Cane Island 2
Combustion Turbine Major Inspection & Steam Turbine Minor Inspection
RFP# 2026-207

Questions & Answers – Revision 2 – 6/8/26

Figure 2: CIPP CT2 Generator Nameplate

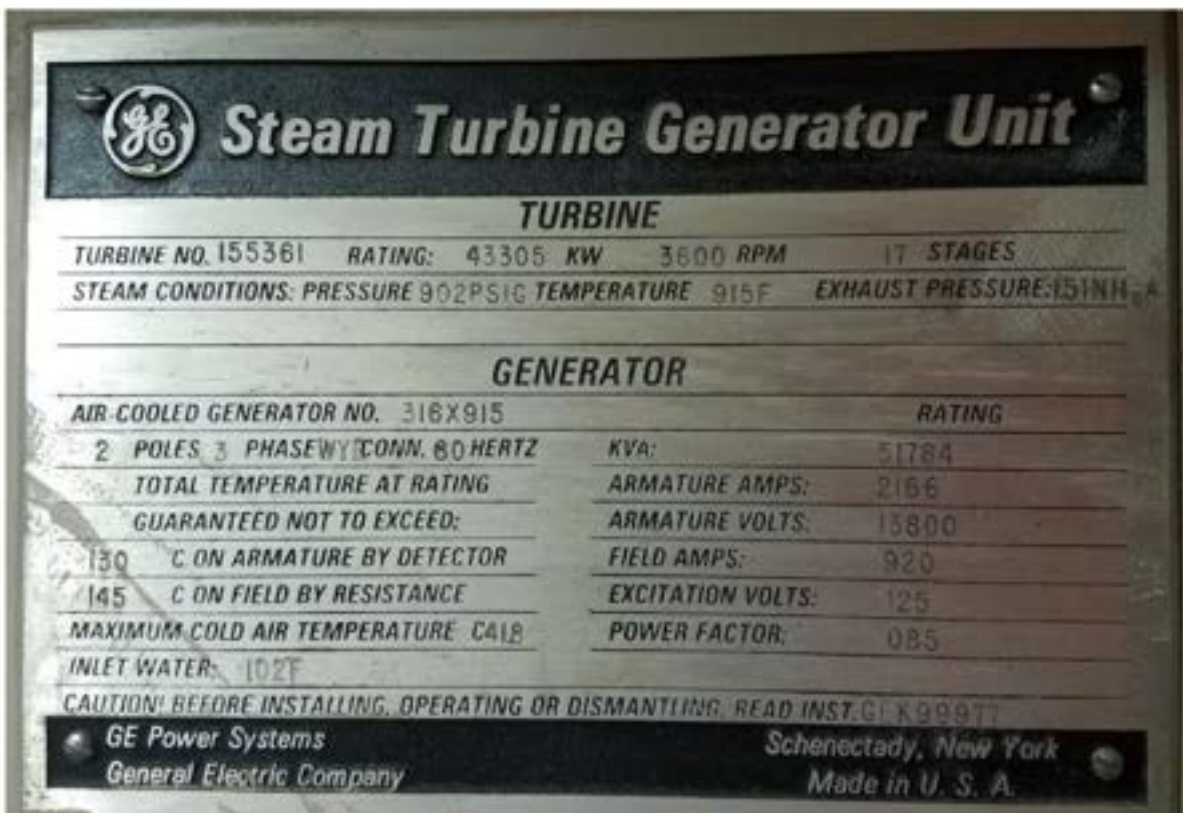
5Q: Would it be possible to get a picture of the nameplate of each generator? Or the information from the nameplate?

5A: See attached.

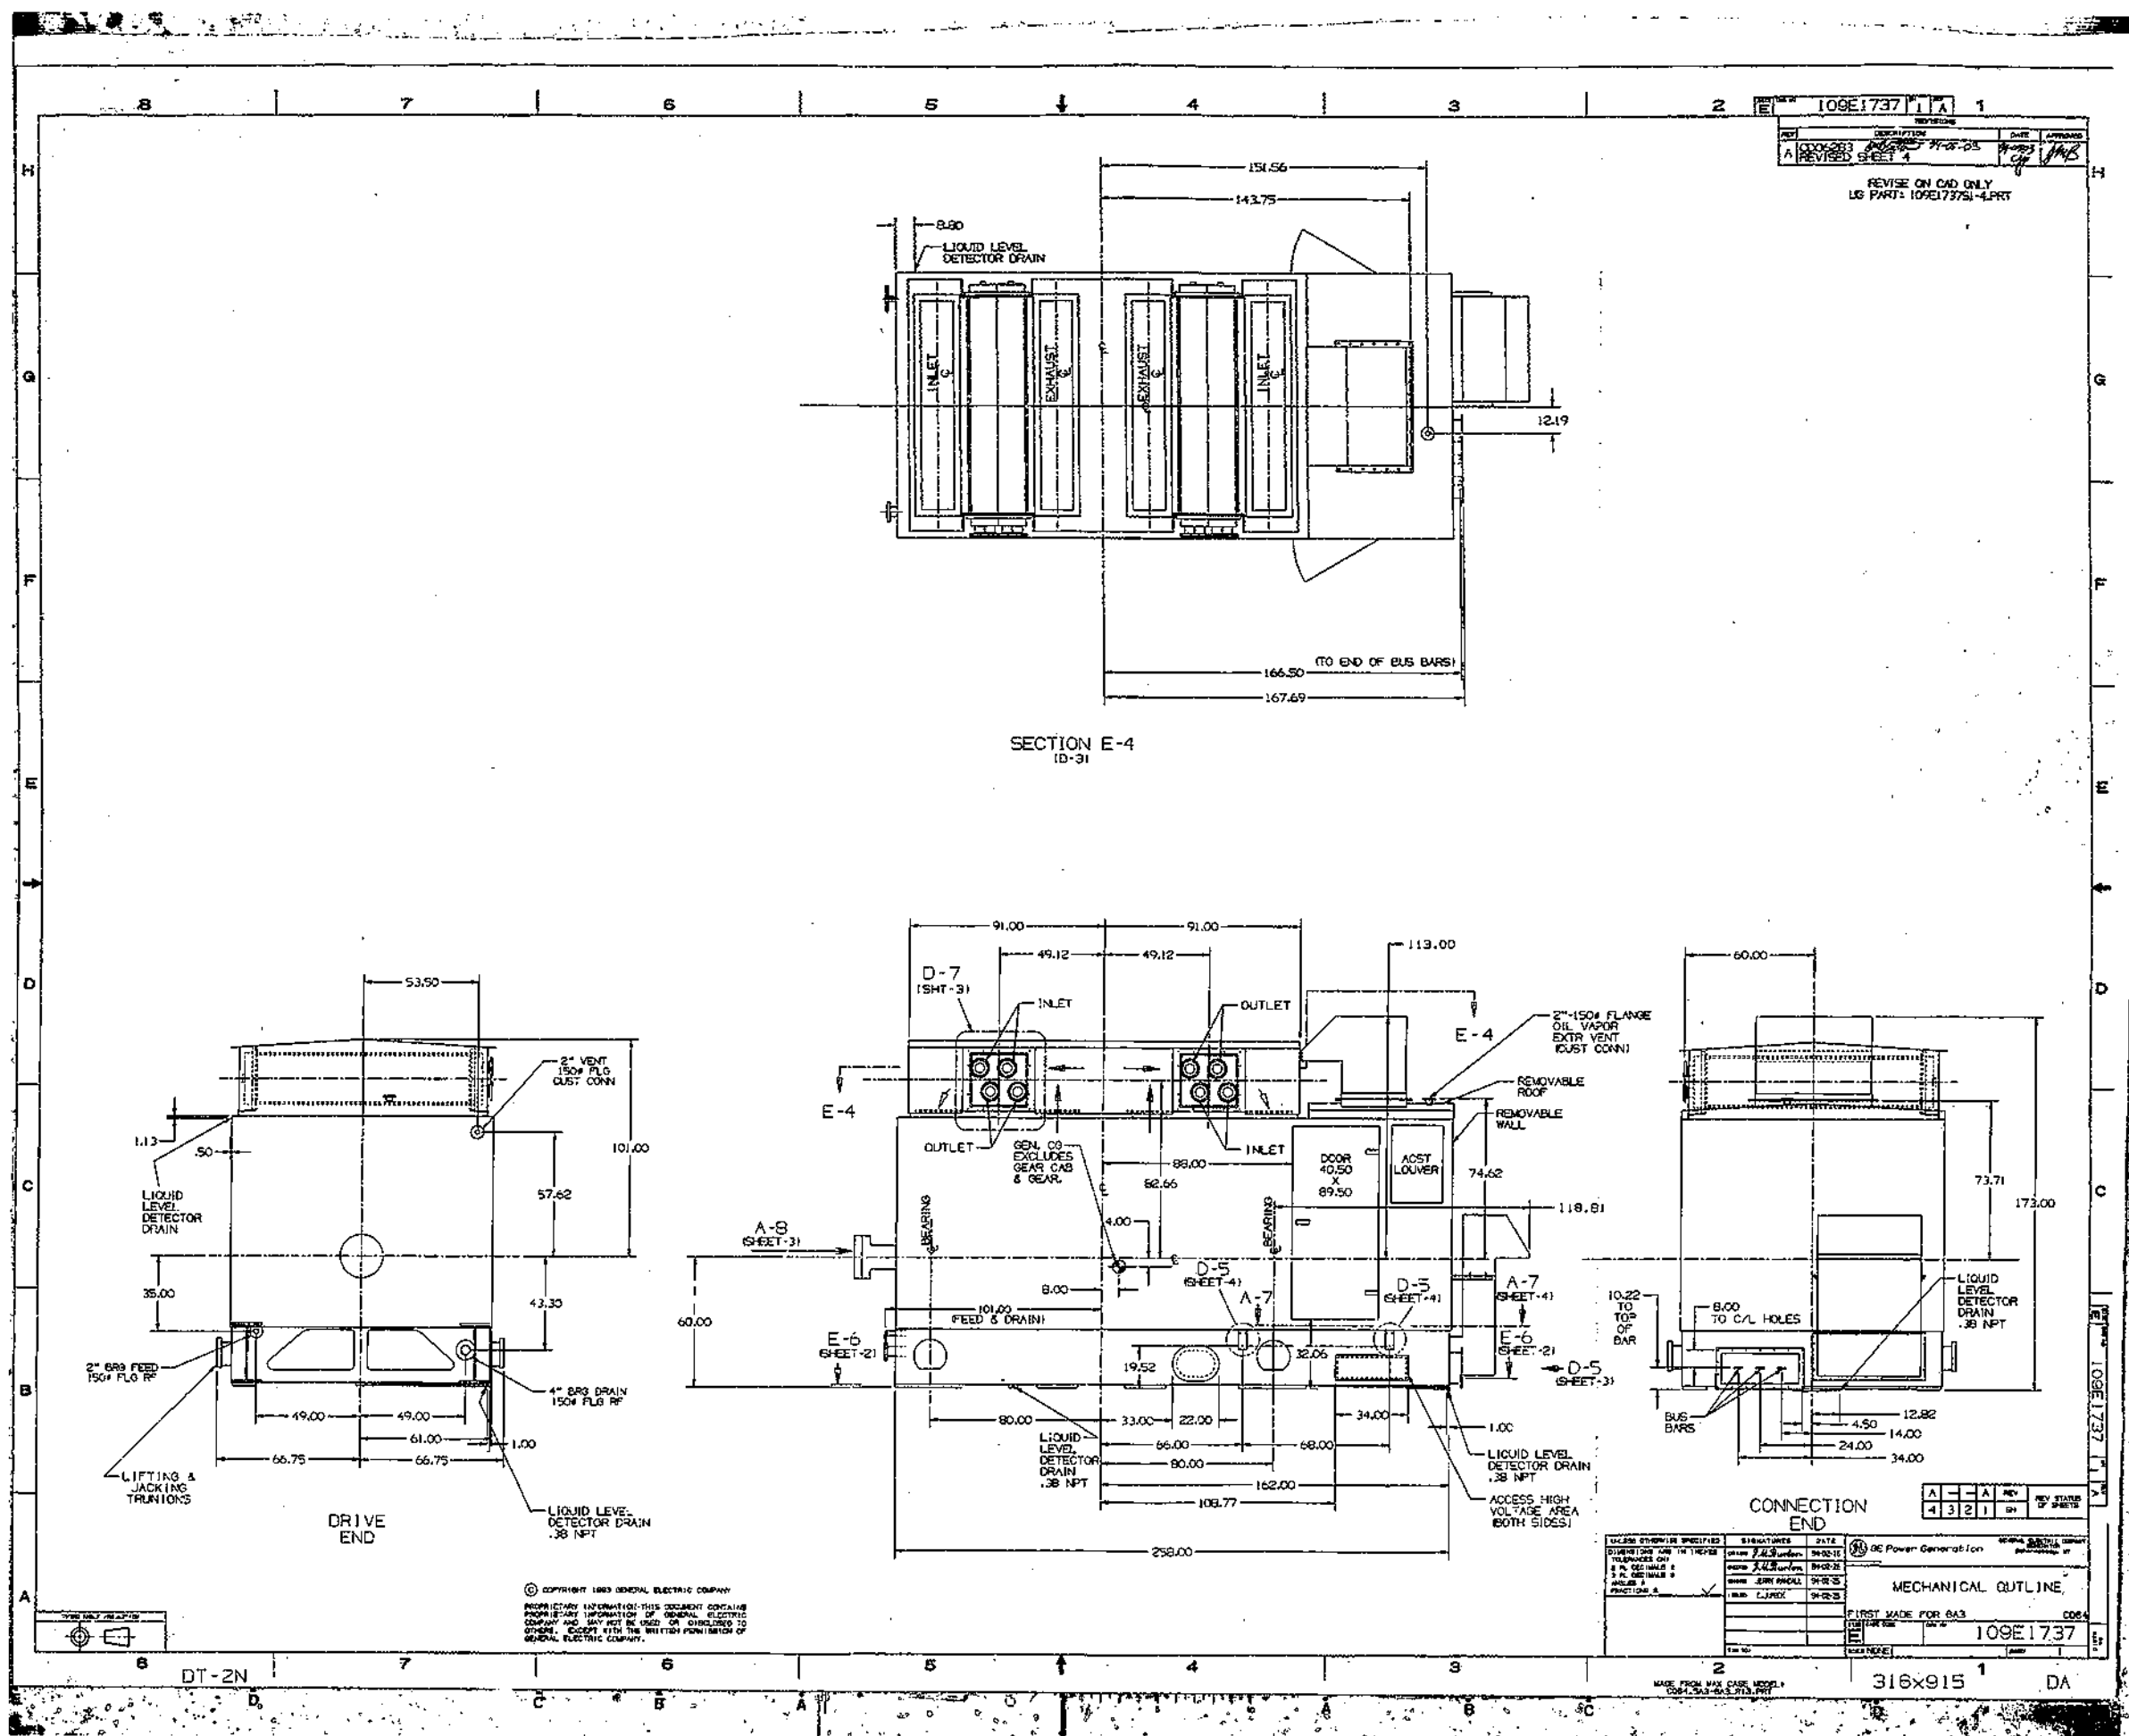
14Q: Provide multiple pics of the steam turbine and generator all sides

14A: Attached

MECHANICAL OUTLINE

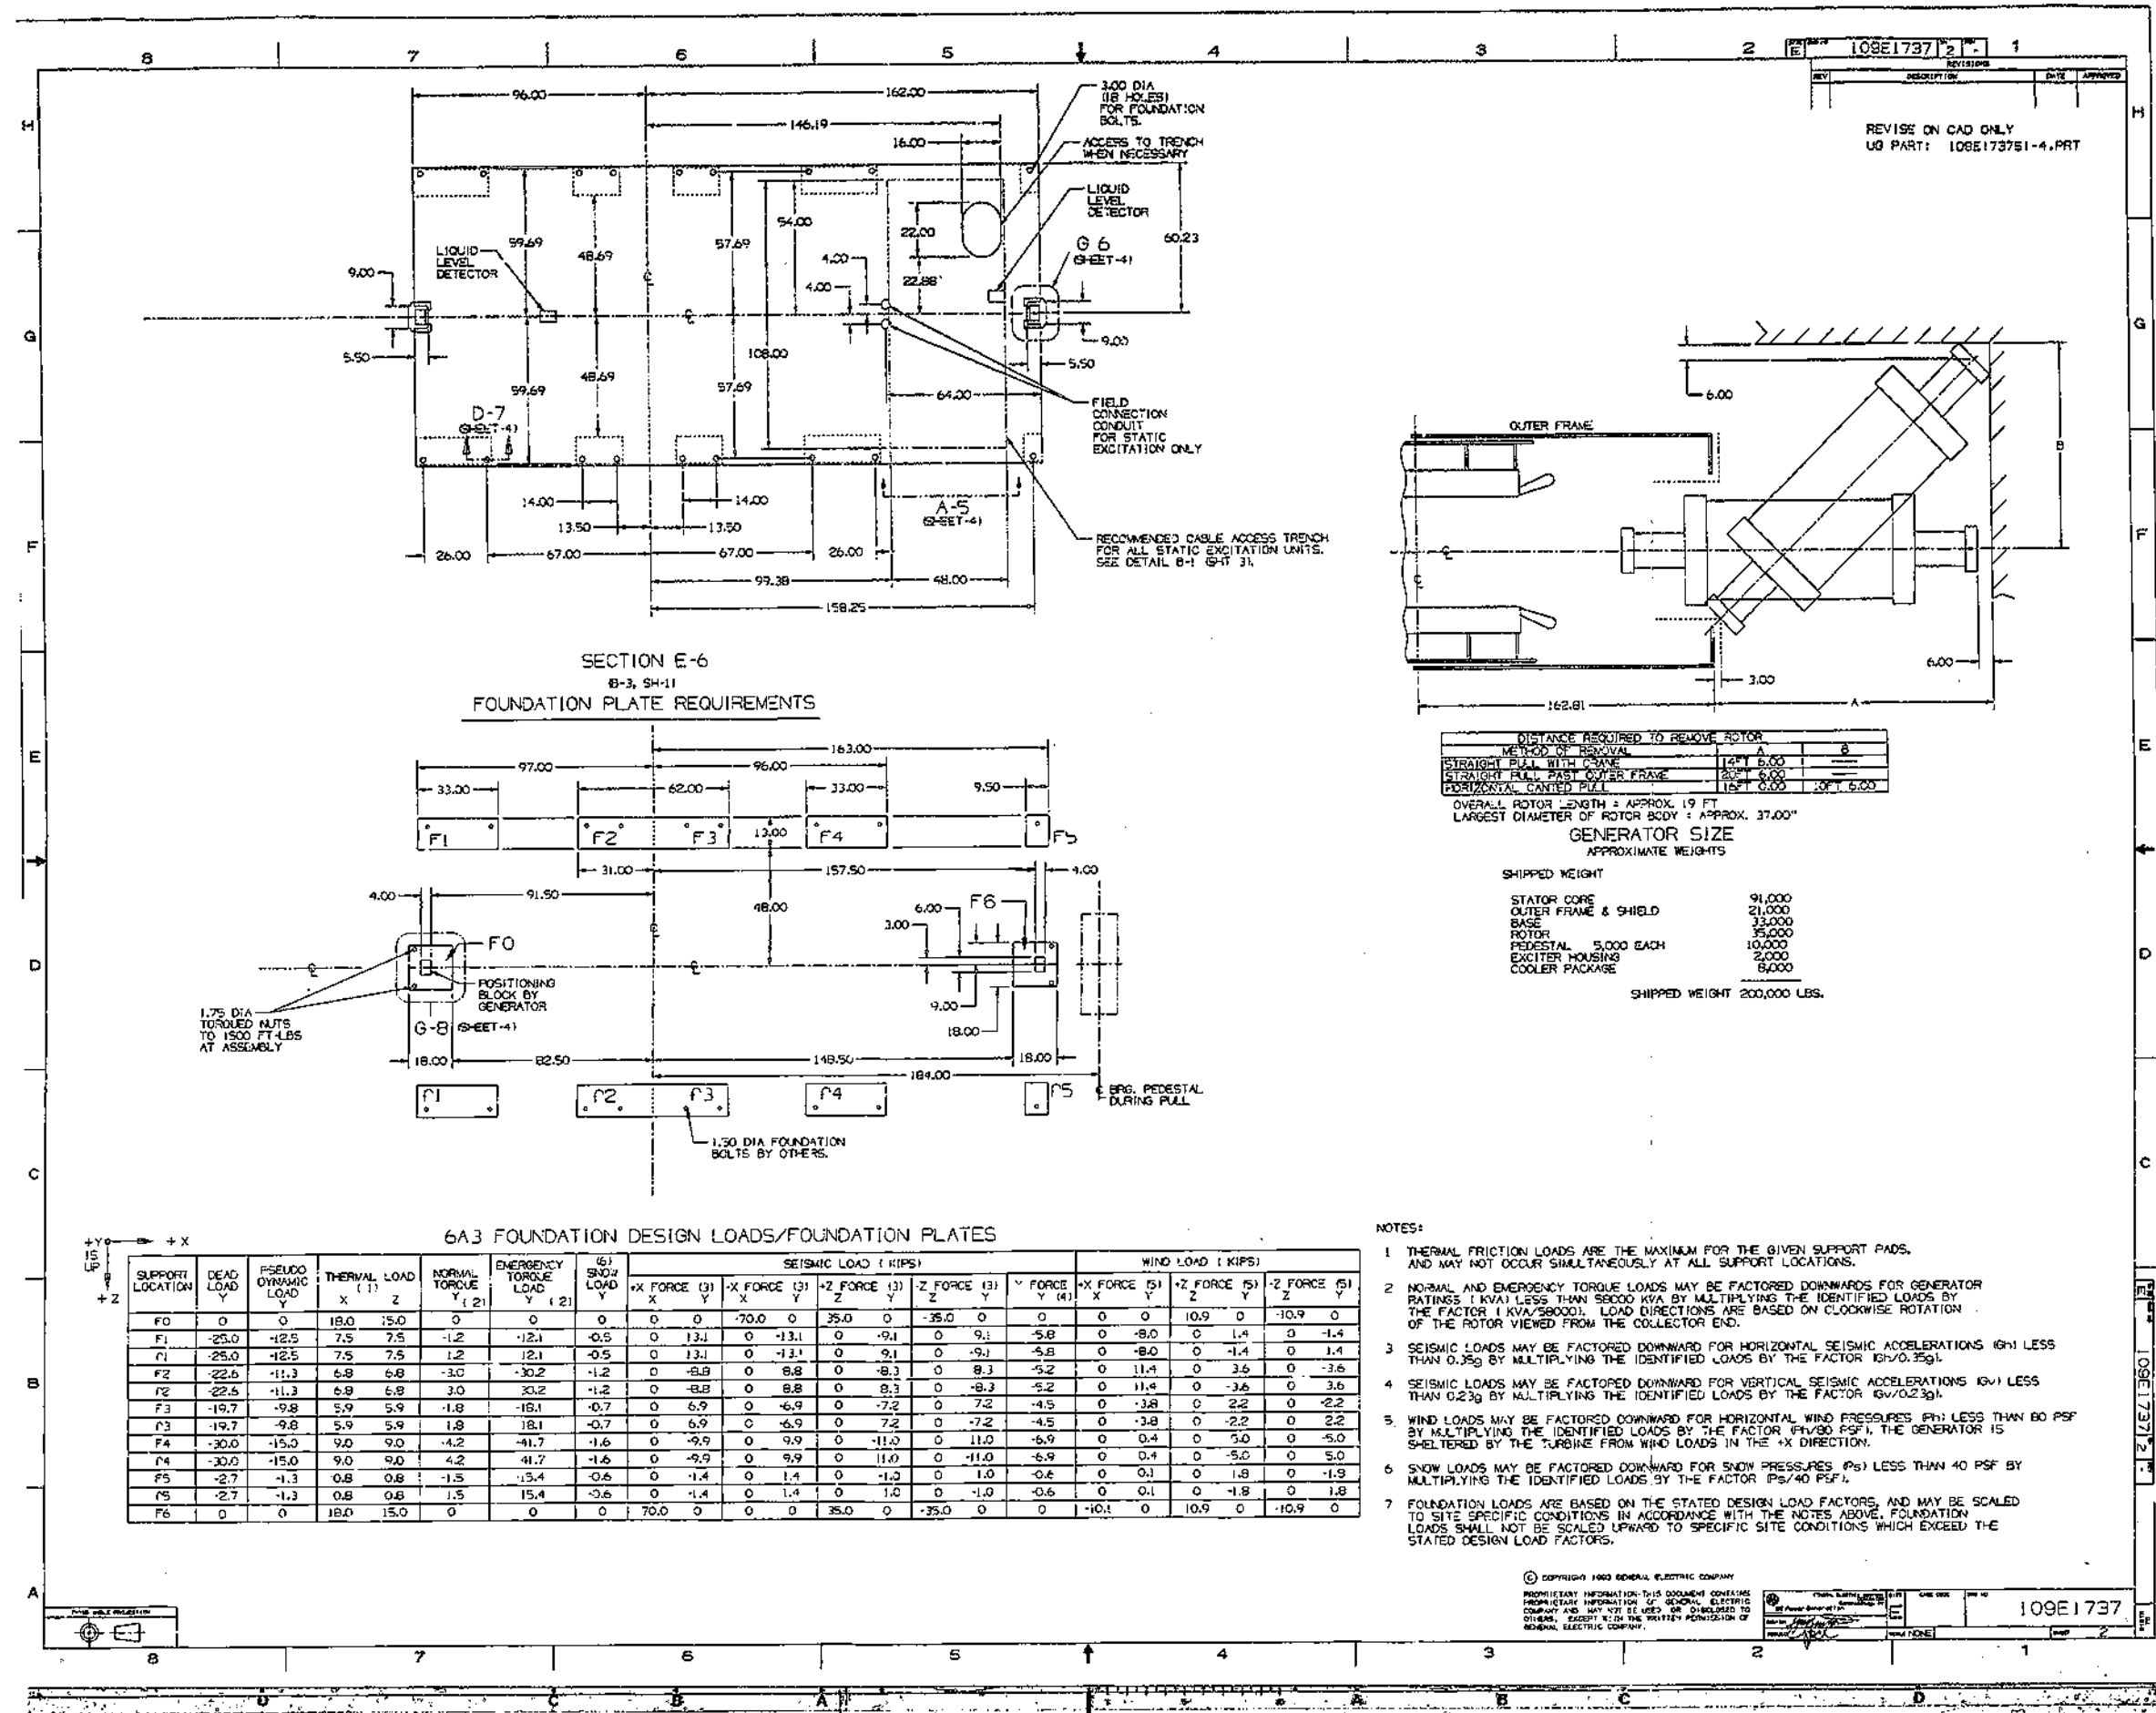
15Q: Provide mechanical outline dwg for steam turbine and generator

15A: Attached
